March 17, 2023

VA-23-00004 Kosar

ON SITE SEWAGE INSTALLATION PERMIT

Site Sketch / As-Built Drawing

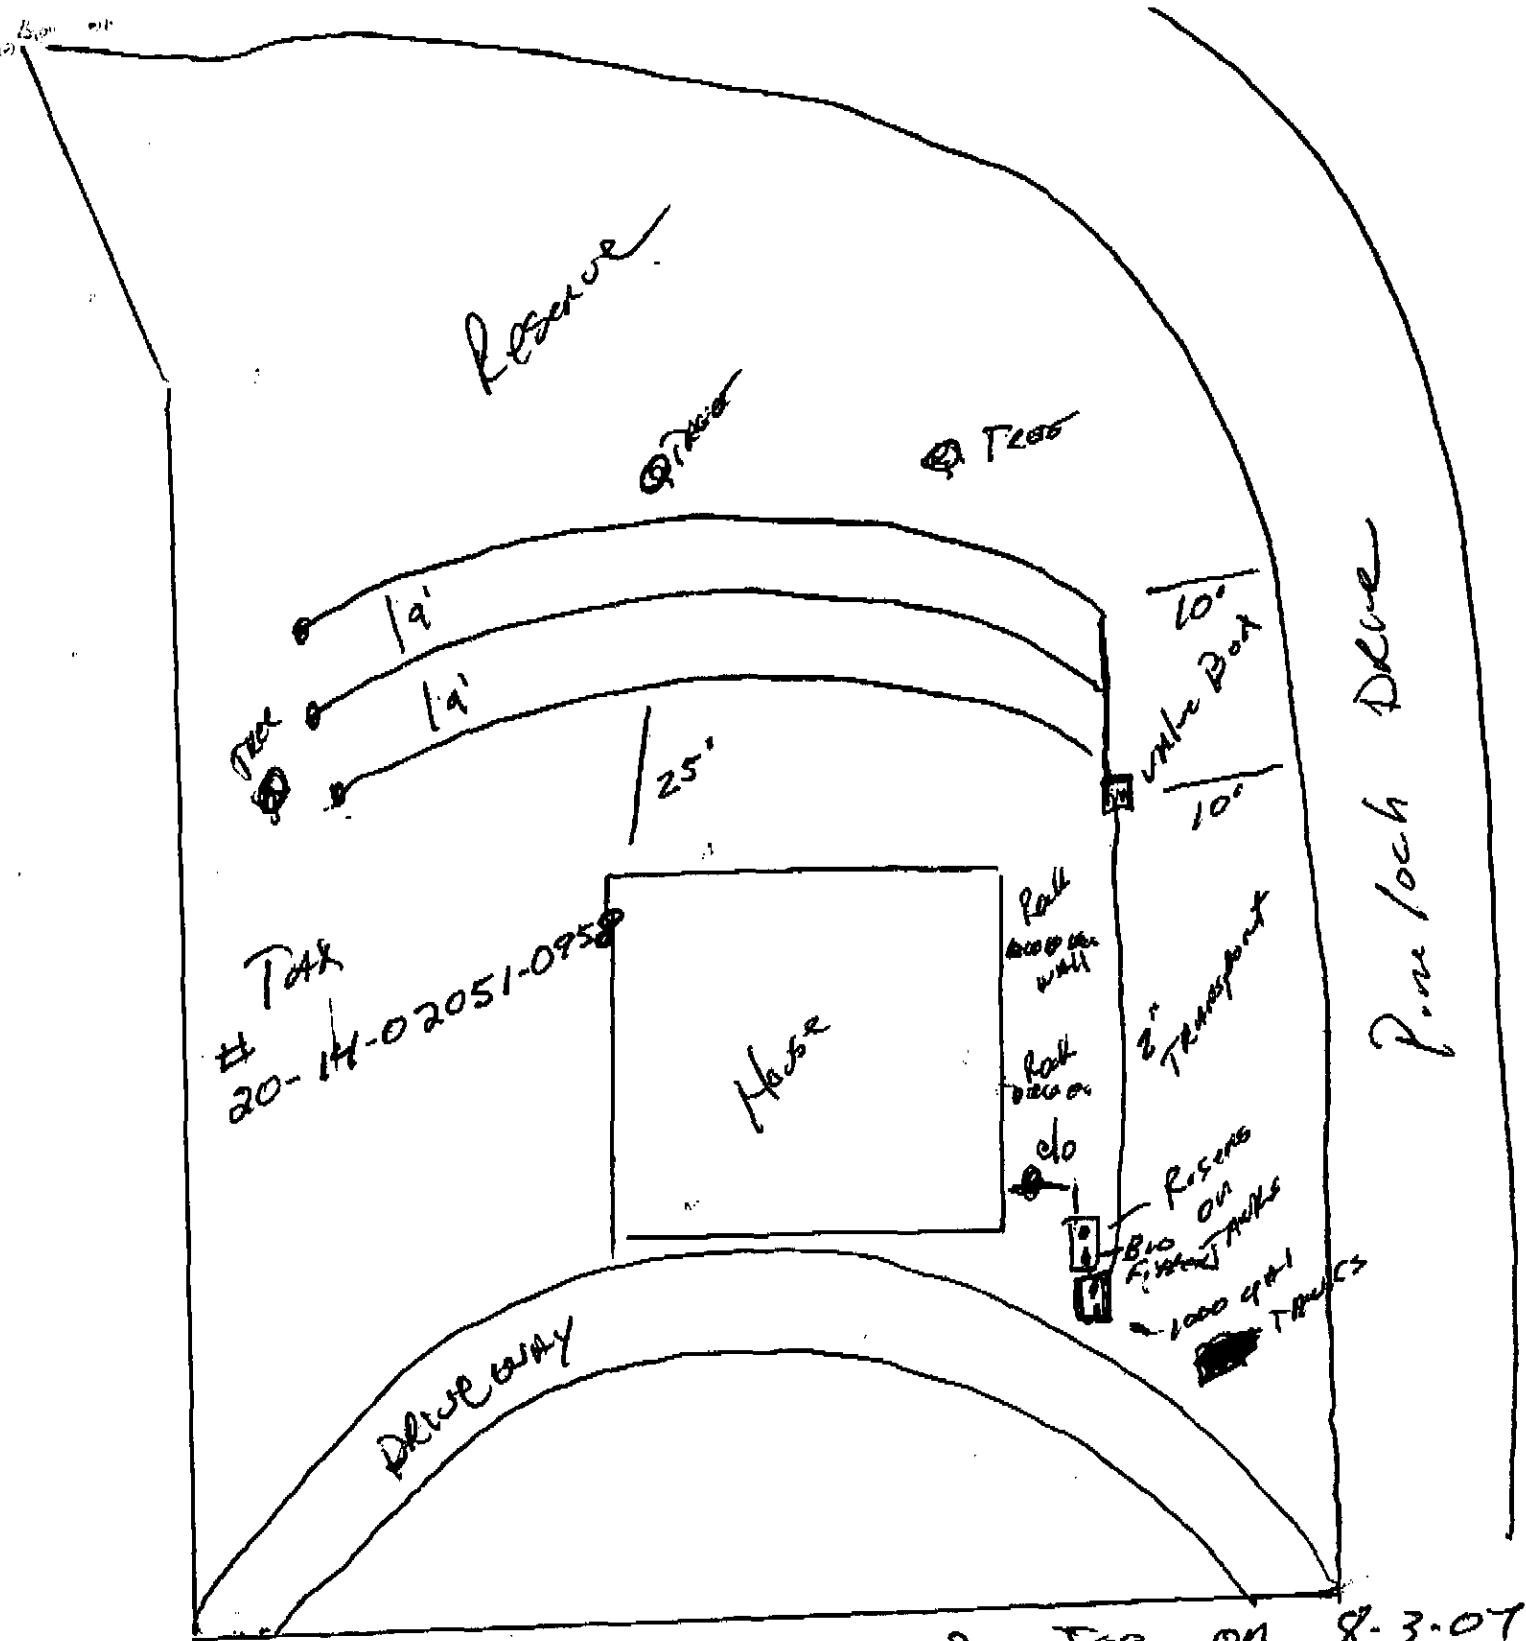
The current septic system and designed listed reserve area is where the proposed garage will be. KCC 13.04.080, requires that no impervious surface be placed above an on-site sewage disposal system or a reserve area.

The applicant will need to propose a smaller structure or a new location.
